# **City of Portland**

**3rd Design Advice Request**

**EA 15-125245 DA**

**1417 NW 20<sup>th</sup> Avenue**

## 3. Public Square

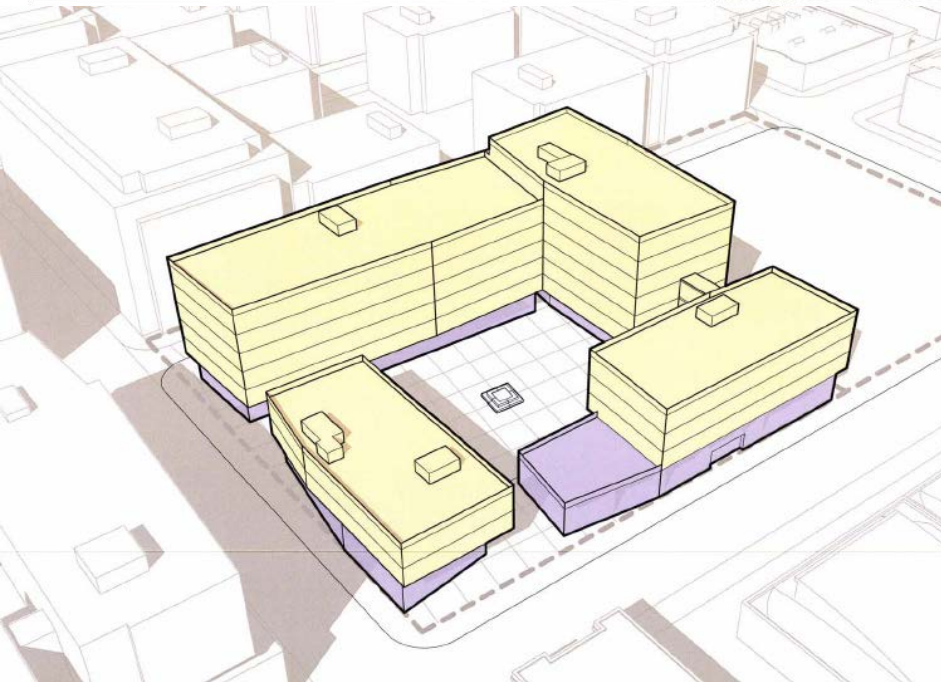
***Solar Studies provided show minimal difference between proposed heights and a 6-5-4-3 model***

***Is the square the right size? Are the surrounding buildings the right height? Is the square permeable enough from the right-of-way?***

# Proposed & Previously Proposed Footprints

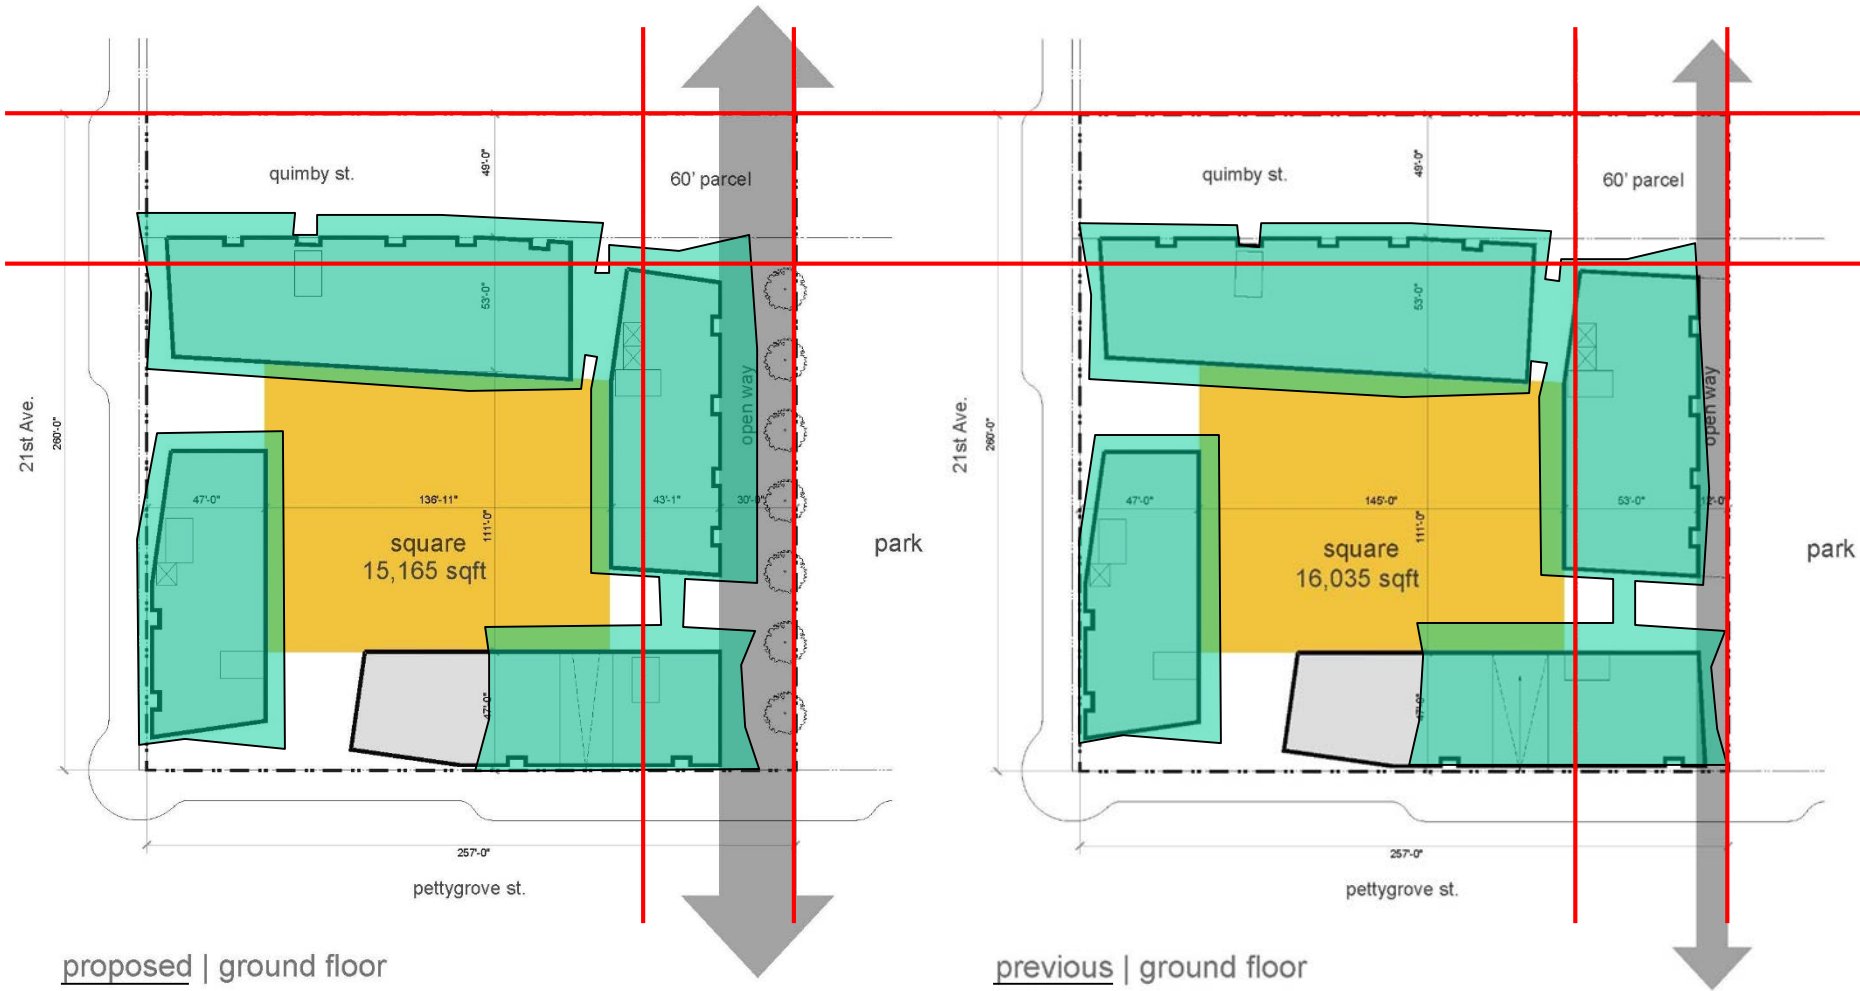
***The first version showed the building extending 60' into the western portion of the Park; the current version extends 30' with a 12' overhang.***

***Is this enough to ensure connectivity and plentiful open space?***

# Quimby

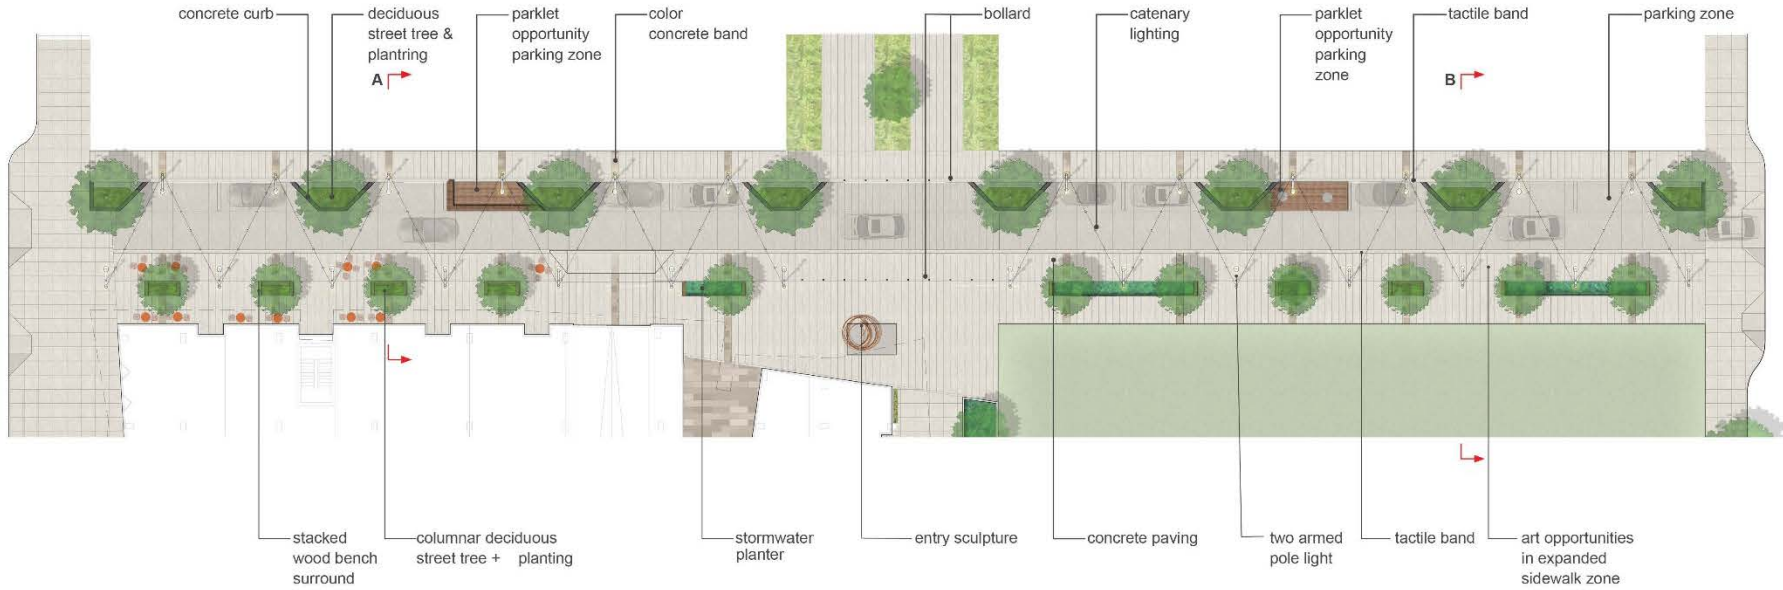
***The proposal shows the building to encroach into the Quimby festival street, which is envisioned in the Master Plan primarily for bicycle and pedestrian use.***

***Garage access is now shown on Quimby in response to neighbor comments.***

***Staff notes that Quimby cannot be closed down for festival use if it is also used to access the garage and strongly suggests that garage access be provided on Pettygrove (requires a Master Plan Amendment).***
